Nov 2020

Issue to resolve

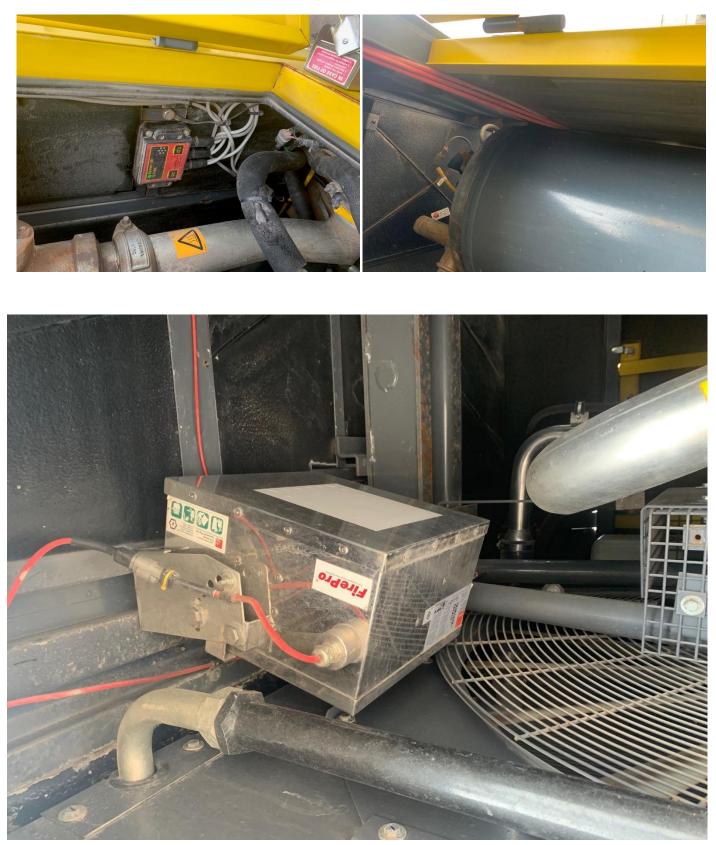
• Install PClips for cable throughout
